Memorandum to the City of Markham Committee of Adjustment

File: A/072/22
Address: 10 Outlook Terrace Drive – Markham, ON
Applicant: Kiran Babu
Agent: Varatha Design Associates (Ken Varatha)
Hearing Date: October 19, 2022

APPENDIX "B"
PLANS TO BE ATTACHED TO ANY APPROVAL OF FILE A/072/22

SITE PLAN

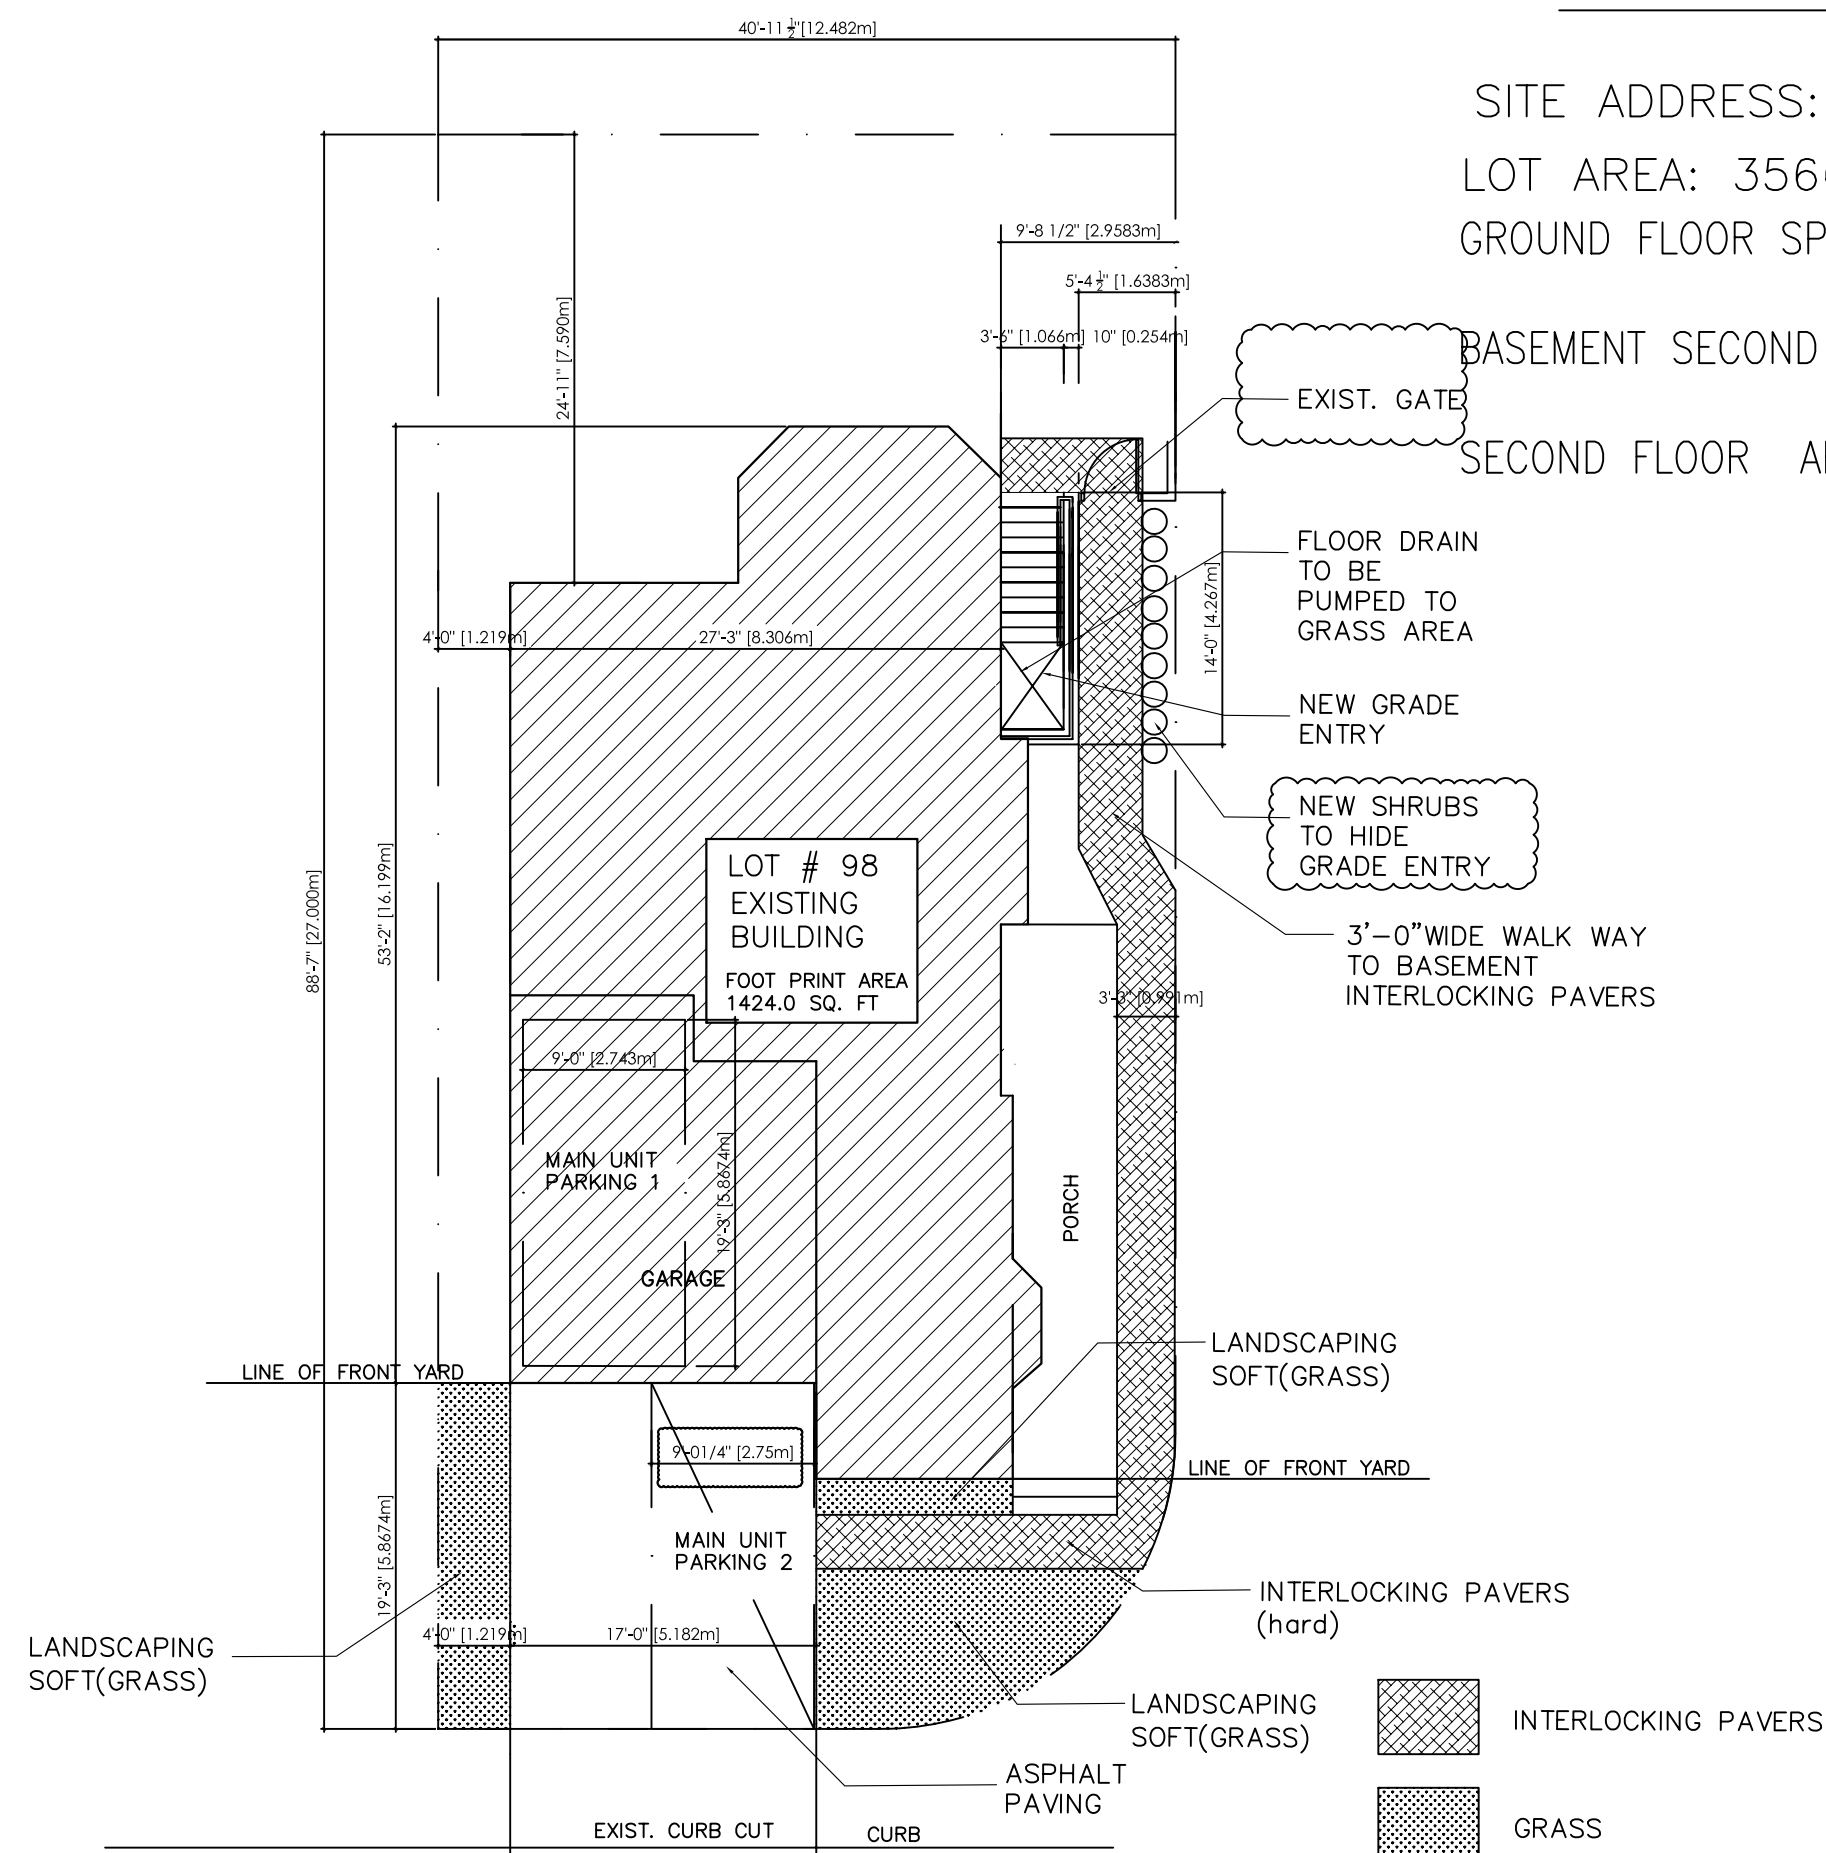
The applicant completed a Zoning Preliminary Review (ZPR), and staff advise that a variance to permit the walk-up stairs in its proposed location was not identified by the ZPR and is not being requested by the applicant. Staff's review of a Minor Variance application is an assessment of whether the requested variances meet the four tests under Section 45(1) of the *Planning Act, R.S.O. 1990, c. P.13, as amended* (the "*Planning Act*").

Following the initial hearing, the applicant submitted a revised Site Plan (attached as Appendix "B" to this report), which shows new shrubs proposed east of the walk-up stairs. The requested variances remain without change, and staff comments in the initial staff report dated August 15, 2022 remain applicable (see Appendix "C").

SITE PLAN

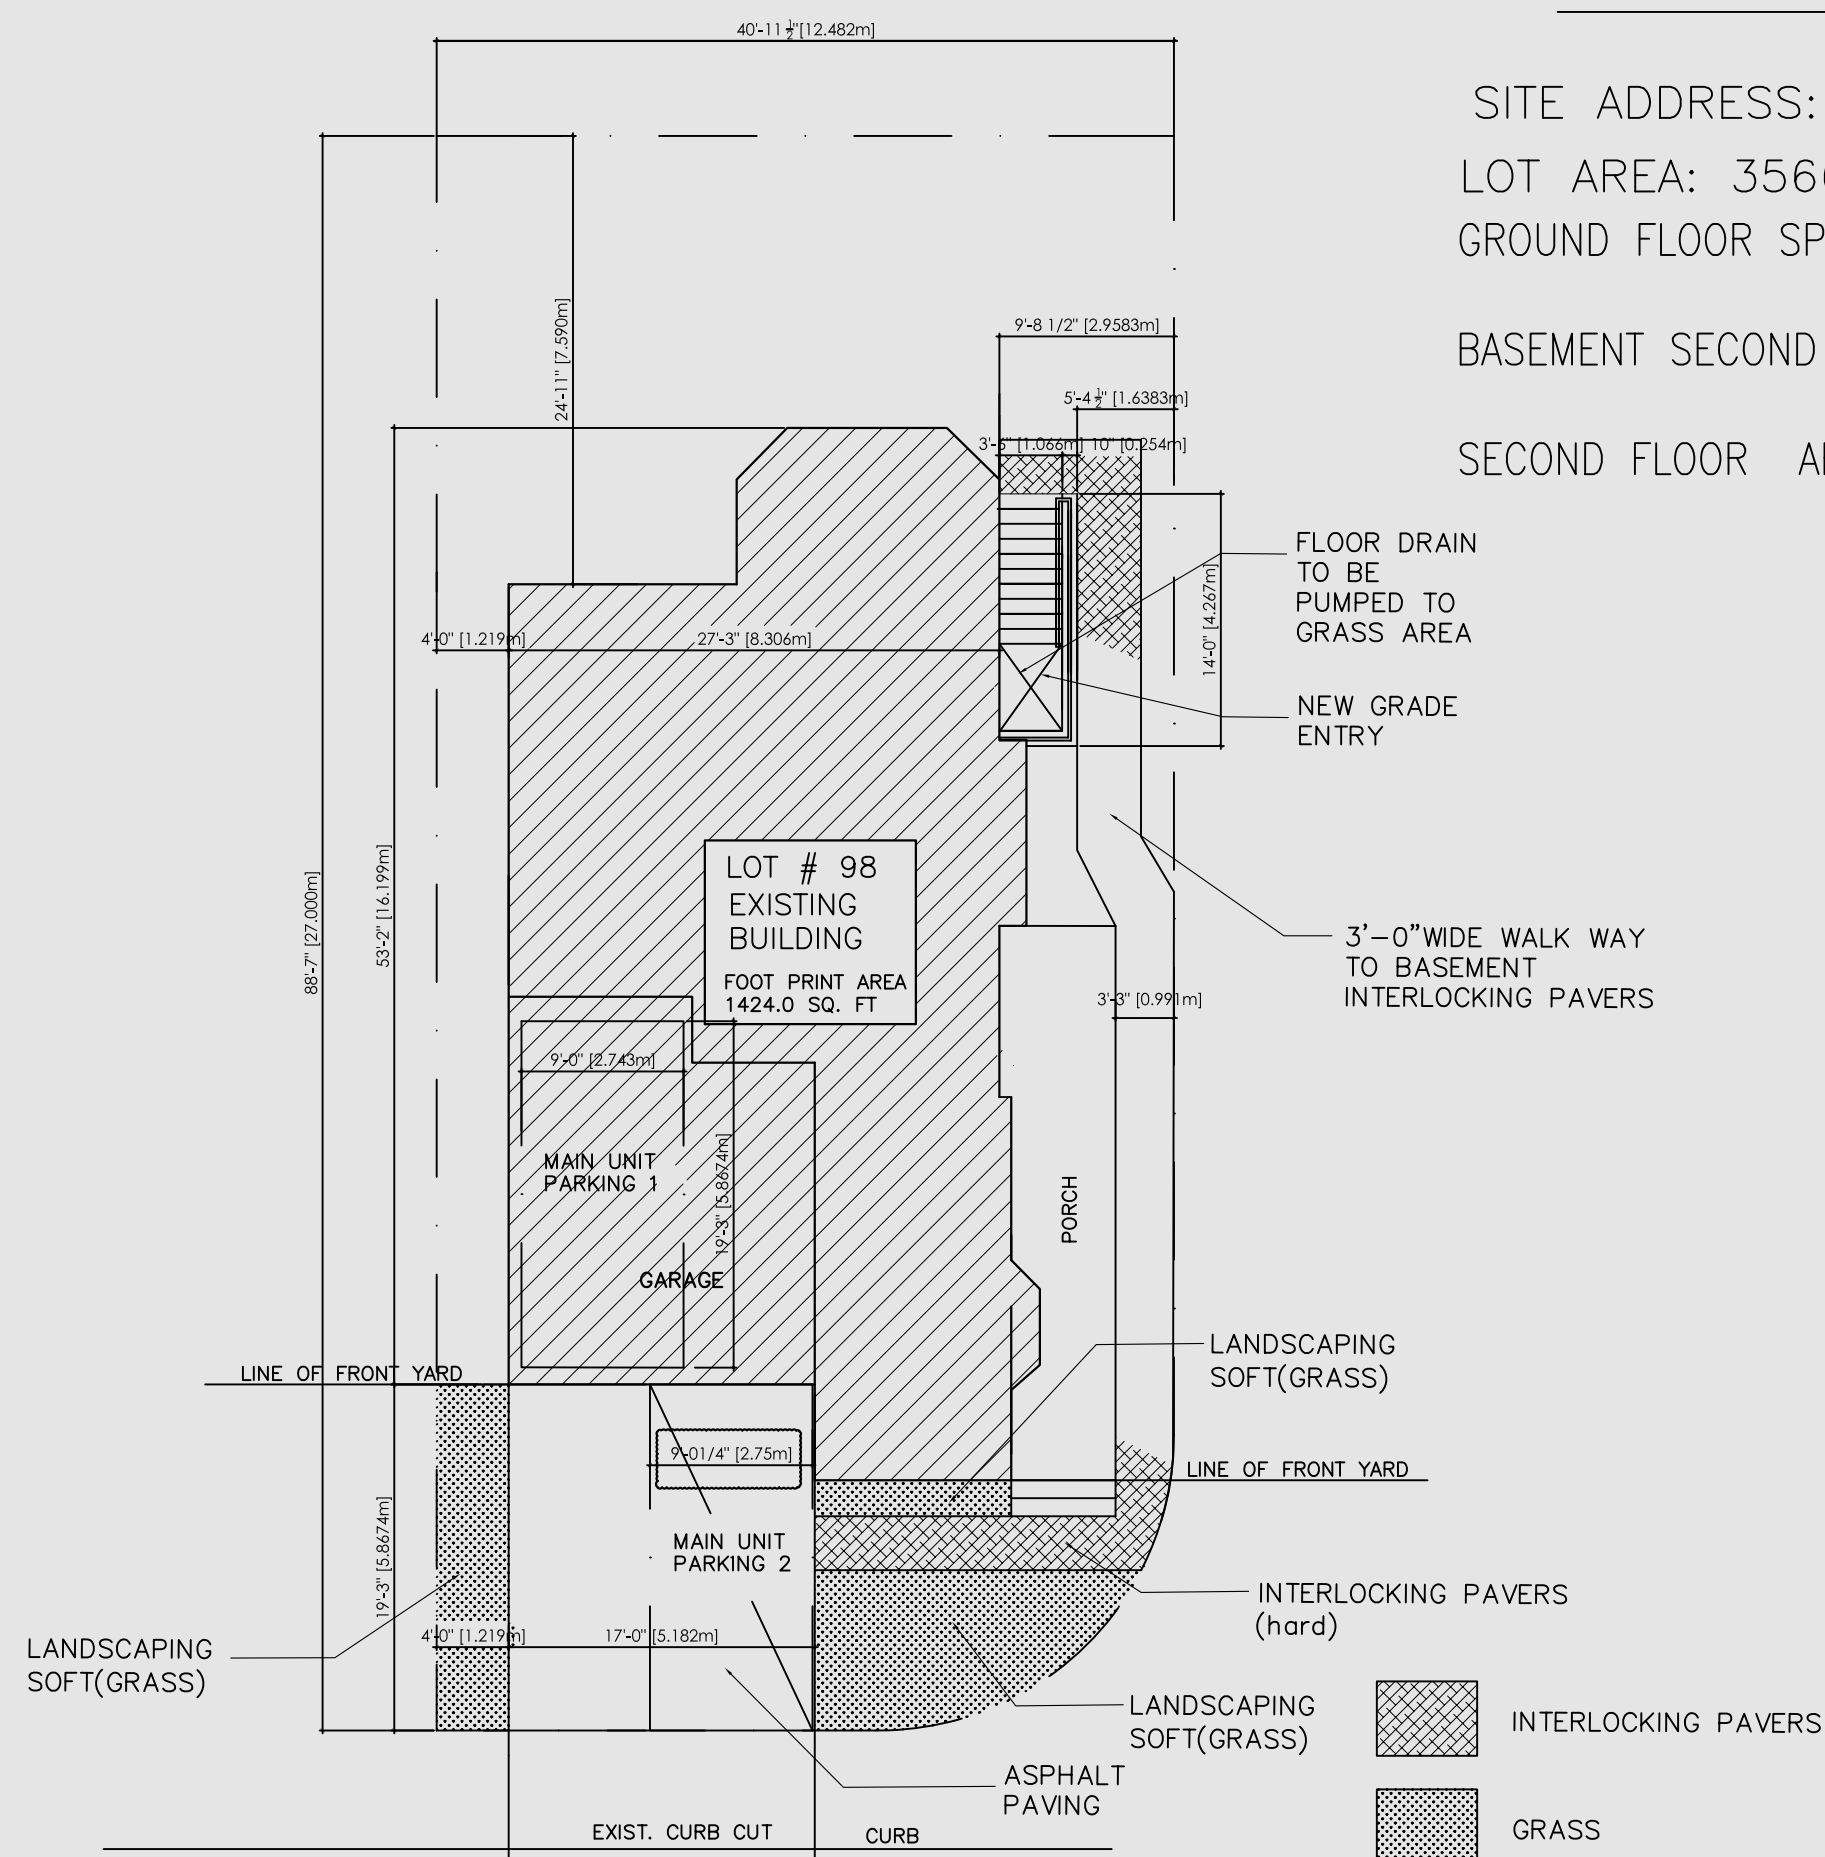
The variance is attributable to the proposed walkway, and existing driveway. If approved, the walkway would serve as a logical extension connecting the driveway area to the proposed main entry points for each unit located along the exterior side yard. Staff are of the opinion that the reduction in soft landscaping is minor in nature, and appropriate for this lot.

Ken Varatha indicated that it was not shown on the plan, but the side yard fence would be extended past the proposed walk-down and entrance with a gate so that the railing would not be visible from the street.

The Chair identified a detailed landscaping plan, Site Plan A 1.5, had been submitted with the application, and the plan did not show the proposed fence extension. The Chair indicated that the application had addressed parking standards, and a decision cannot be based on a breach or potential breach of other laws.

The Chair recommended deferral of the application to provide staff with an opportunity to work with the applicant to determine the appropriate method to provide screening for the proposed door.
